Subject: Transmittal of "Analysis of Niche Studies and Development of Bases for Total System Performance Assessment Seepage Parameters—Letter Report" (IM 1402.861.010)

**ANALYSIS OF NICHE STUDIES AND DEVELOPMENT
OF BASES FOR TOTAL-SYSTEM PERFORMANCE
ASSESSMENT SEEPAGE PARAMETERS**

**Center for Nuclear Waste Regulatory Analyses
San Antonio, Texas**

March 2000

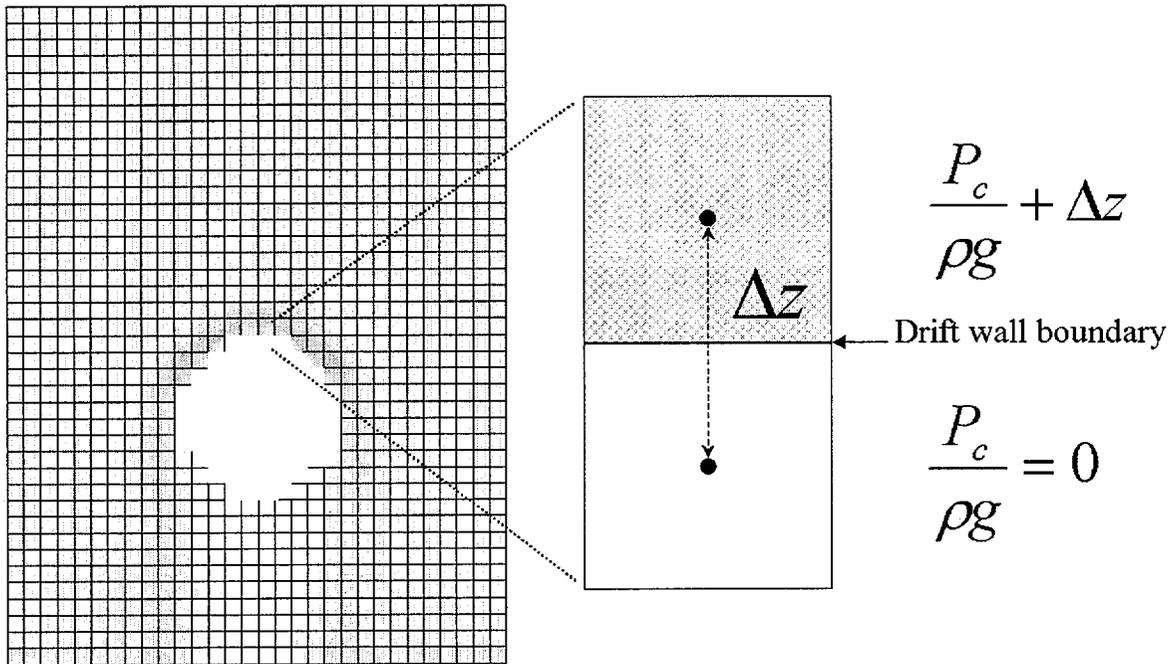
Despite incorporating comments from the DSPR, the proposed SCM still has significant shortcomings that render it inadequate to address or to bound the potential seepage volume and fraction of affected WPs. The SCM is based on small-scale (0.65 m), short-term (a few hours), high-volume liquid-release tests within the zone dried out by ventilation in the ESF. The SCM does not account for

moisture lost to evaporation during the field test, nor does it model matrix imbibition explicitly. Instead, the effect of matrix imbibition is reflected in an effective porosity obtained through inverse modeling. Nodal connections between the mesh elements of the SCM and the niche ceiling boundary are arbitrarily set to 0.05 m. Model calculated seepage into drifts is sensitive to the distance between the drift wall boundary and the node of the element immediately above.¹ Seepage flux will cross the drift wall boundary when saturation at a point just inside the rock formation reaches 1.0. Defining the drift crown as a reference elevation for convenience, this occurs when capillary pressure and total potential in the rock at the drift crown are zero. By connecting the mesh element node to the boundary with a nonzero vertical component, a gravity term equal to this vertical distance is added to the total potential (figure 2-2). Thus, seepage will cross the drift wall boundary when the pressure immediately inside the rock formation plus this gravitational term slightly exceeds the pressure inside the drift. This results in flux crossing the drift wall boundary at model saturation in the rock less than 1.0. Consequently, an α parameter determined by inverse modeling to match test data of seepage flux with a nonzero vertical connection distance between the drift wall boundary and the mesh element node is merely a fitting parameter that has no physical meaning or relationship to fracture characteristics such as aperture. Treating α as a fitting parameter to be adjusted through inverse modeling may still produce acceptable results but probably only if the inverse calibration is to data representing conditions expected in the repository following the thermal period. The α parameter calibrated in this manner, however, is specific to the grid used for the inverse modeling.
